CONNECTION ASSESSMENT & APPROVAL PROCESS

PRELIMINARY ASSESSMENT REPORT

*For the 4th Transformer Project at the Imperial Oil Complex in Sarnia.
Installation of a Second 230/27.6kV DESN Station*

CAA ID No. 2001-034

Scott 230kV Voltage: Recorded during the Year-2000

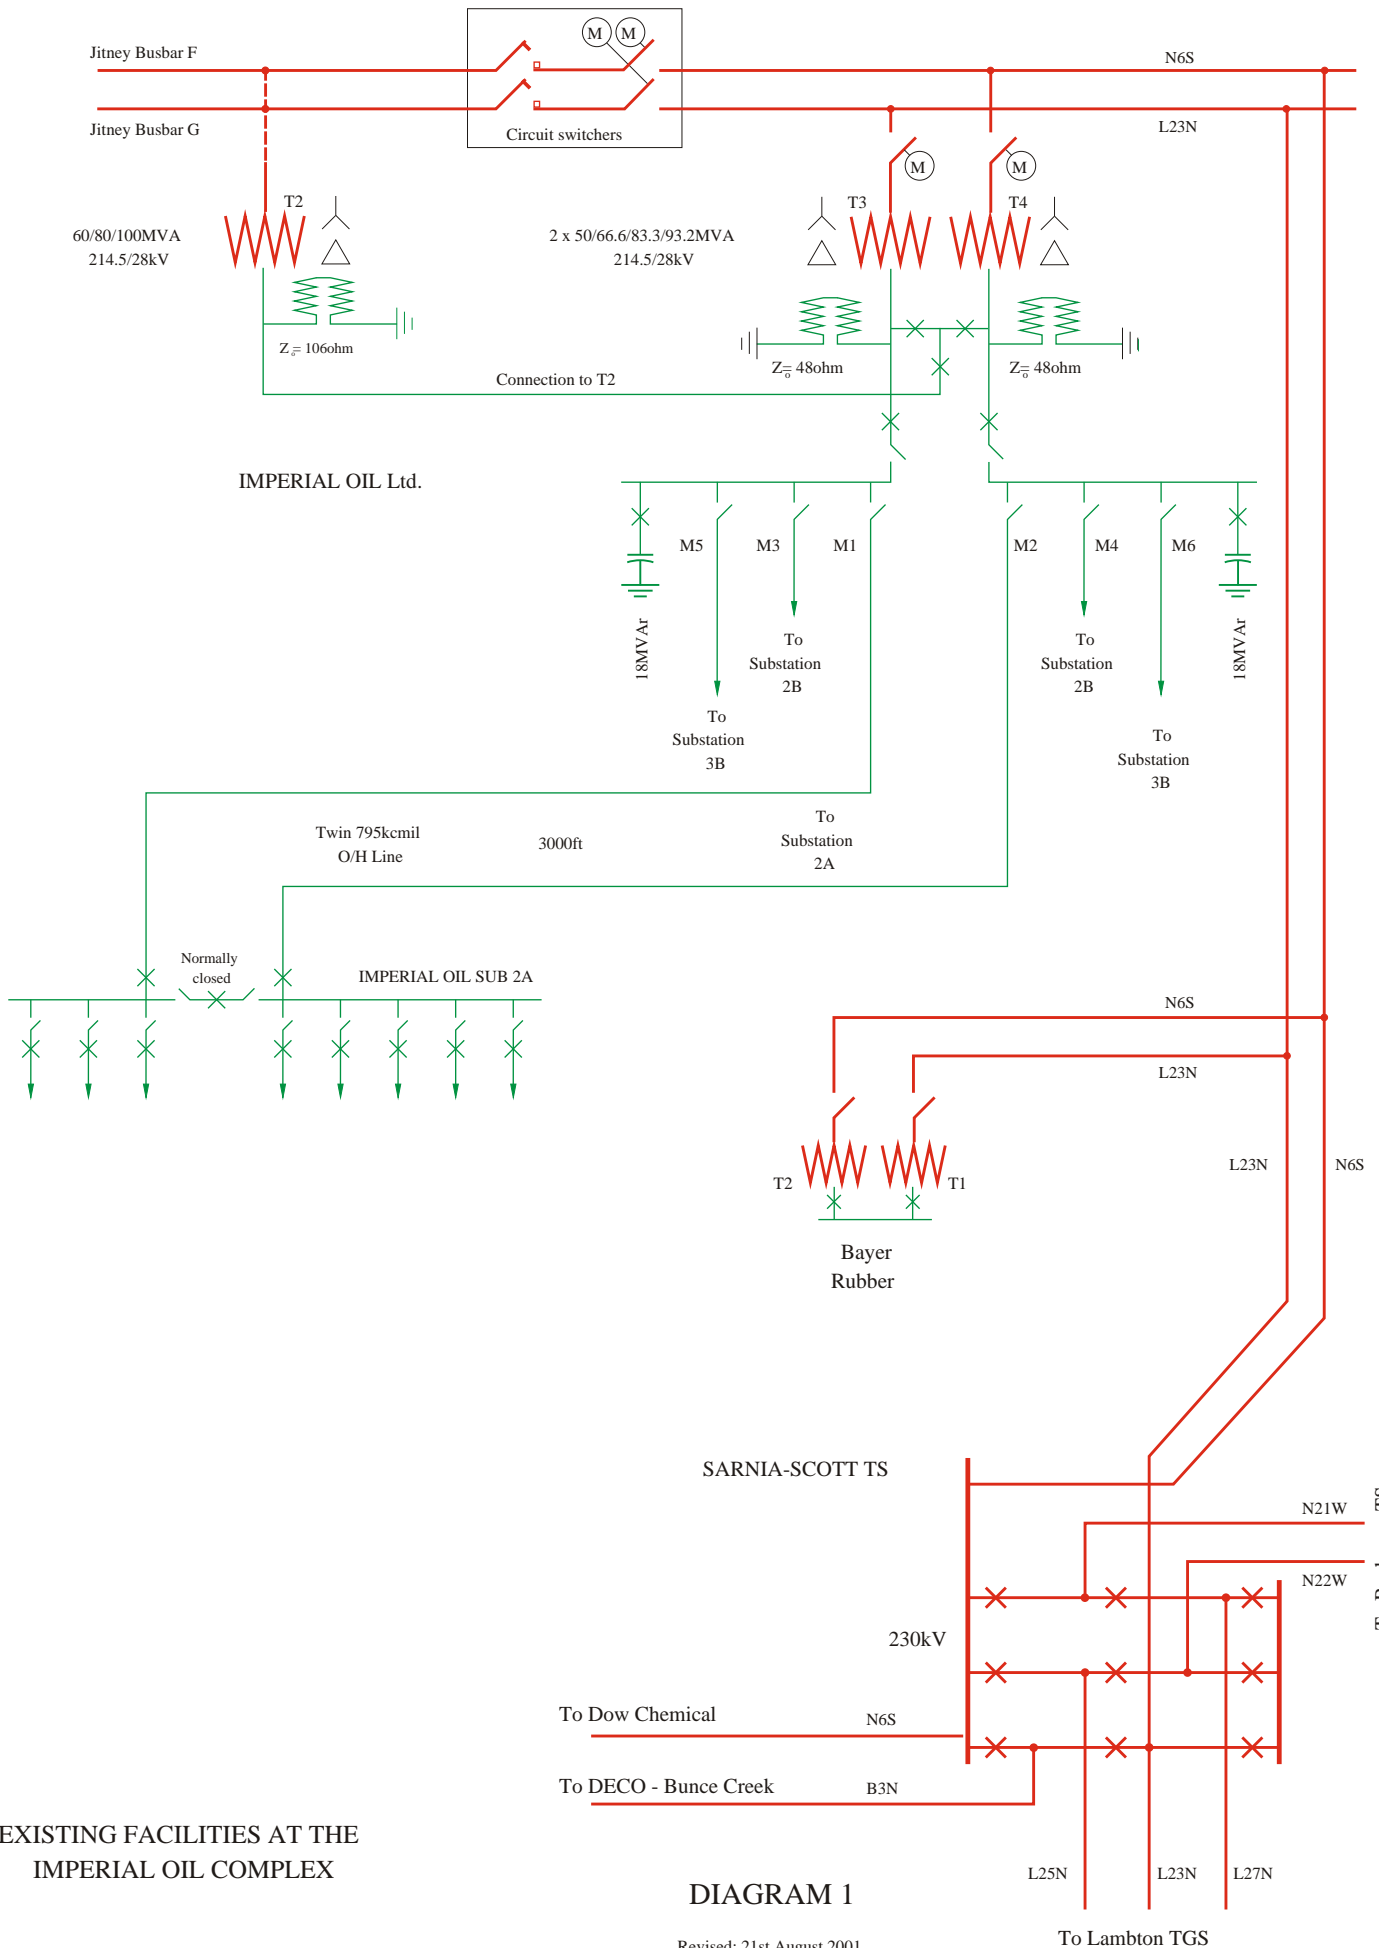
The attached plot shows the voltage profile on the 230kV busbar at Scott TS, recorded during the year-2000. This shows a 'normal' variation in voltage of between 244kV and 238kV. This range is expected to increase once new generation comes into service within the area, and the existing 115kV series-connected reactors are removed from Sarnia-Scott TS. Due to its close 'electrical' proximity, the 230kV voltage at the Imperial Oil Complex will be virtually identical to that at Scott TS.

DIAGRAM 1

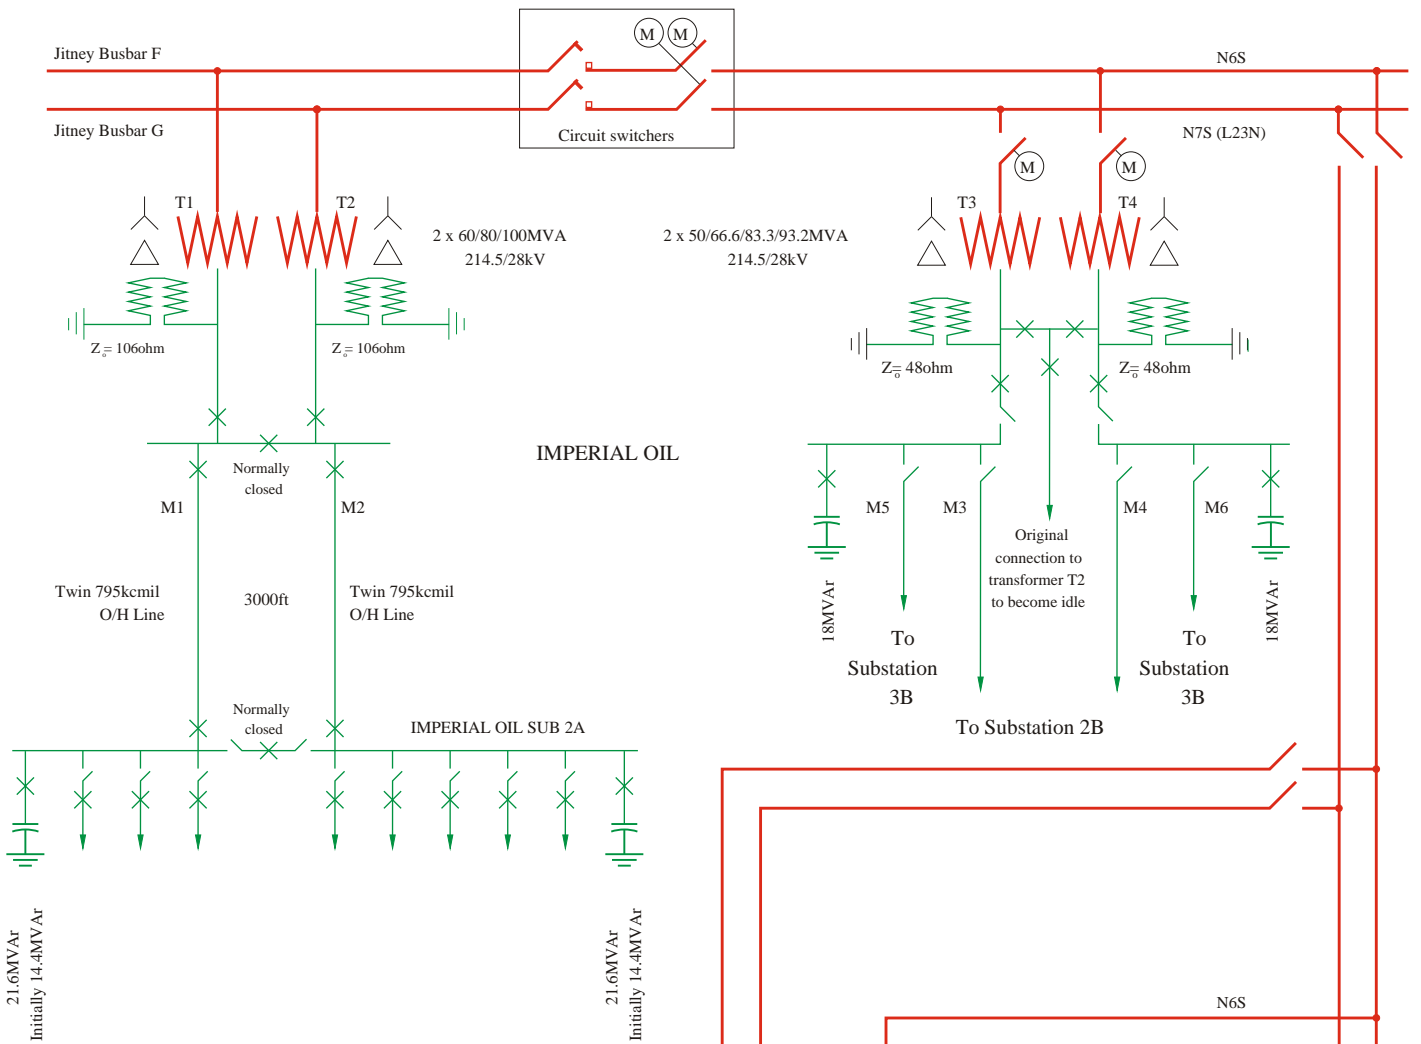
As shown in Diagram 1, two 230kV circuit-switchers, consisting of separately-mounted interrupting (switching) units and isolating devices, are used to connect the switchable-spare transformer to the appropriate 230kV circuit whenever it is required to be brought into service.

The existing supply arrangement at the Imperial Oil Complex consists of a modified DESN station design that employs two 27.6kV bus section breakers to allow the switchable-spare transformer, T2, to be connected to the LV busbar.

The existing connection to transformer T2 from the existing DESN station is to become idle once the new DESN station has been established.
